## Errata for PCI 2.3

This paper lists the known errata for the PCI Local Bus Specification Revision 2.3. If you have found others, please mail them to [techsupp@pcisig.com](mailto:techsupp@pcisig.com).

Figure 5-13: 32-bit Connector

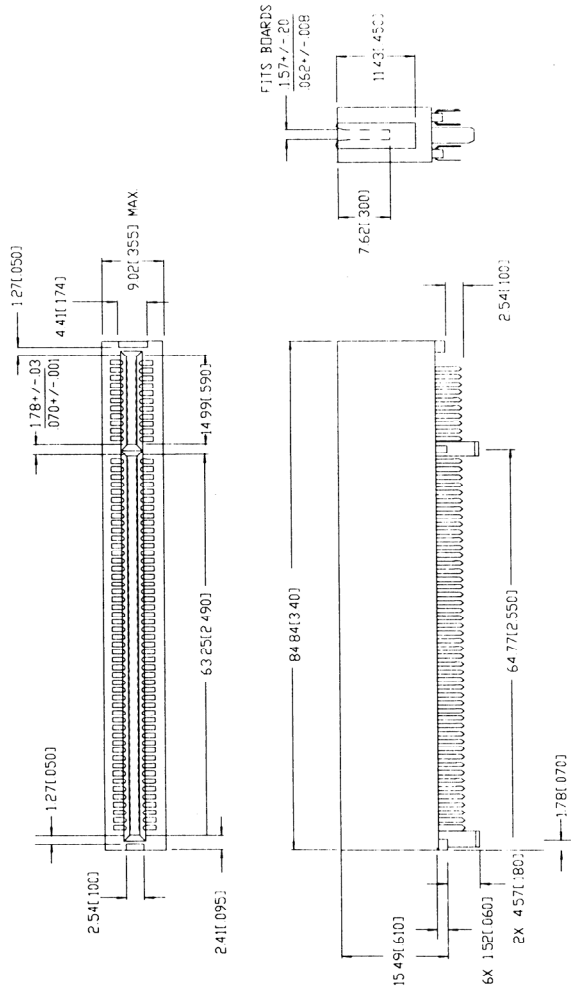
Figure 5-13 is incorrect.

- It is replaced by the following figure (this is the same as Figure 5-19 from the PCI 2.2 specification).
